URFO:CDMC
Docket No. 40-6659
SUA-551, Amendment No. 42
04006659110R
X61207

MEMORANDUM FOR: Docket File No. 40-6659
FROM: Cynthia D. Miller-Corbett, Project Manager
SUBJECT: PETROTOMICS COMPANY, SHIRLEY BASIN MILL: REQUEST TO AMEND
SOURCE MATERIAL LICENSE SUA-551

LICENSE CONDITION NO. 11
SUMMARY

Figure 5.1-1

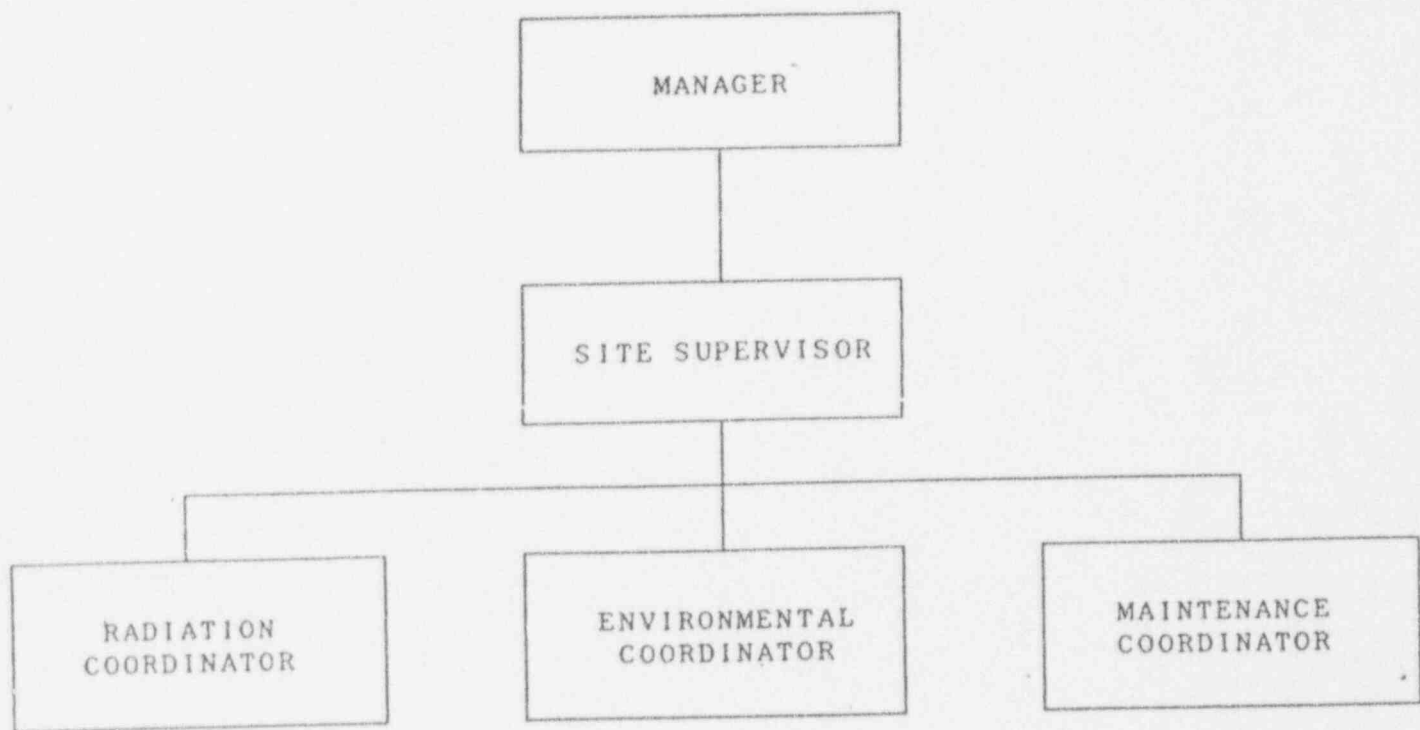
- b. Section 5.1-1: Amend the last sentence of the first paragraph to reflect a change in the parent company location to Denver, Colorado.
- c. Section 5.3-4: Delete the reference to "milling process" for the reason previously noted.
- d. Section 5.4: Revise section to remove the requirement to furnish security guards. Justification for the removal of security personnel is based on the fact that the site is in reclamation status, and all but 6 acres of the tailings impoundment system is covered to meet the less than 20 pCi/l radon emission criteria (See Item 7 below). The only ongoing activities at the site are those associated with the reclamation program. Therefore, there is a minimal chance for human exposure to radionuclides. The licensee's proposed revision is as follows:

1. **SITE SUPERVISOR:** The Site Supervisor is responsible for the reclamation of the mine and mill, and all related facilities and activities associated with the Petrotoomics Site. The Site Supervisor develops and maintains a plan of action to safely ensure the best possible reclamation at the lowest possible cost. The Site Supervisor reports to the Manager, Resources, Alternate Energy and Resources Department, Texaco Inc., Denver, Colorado.
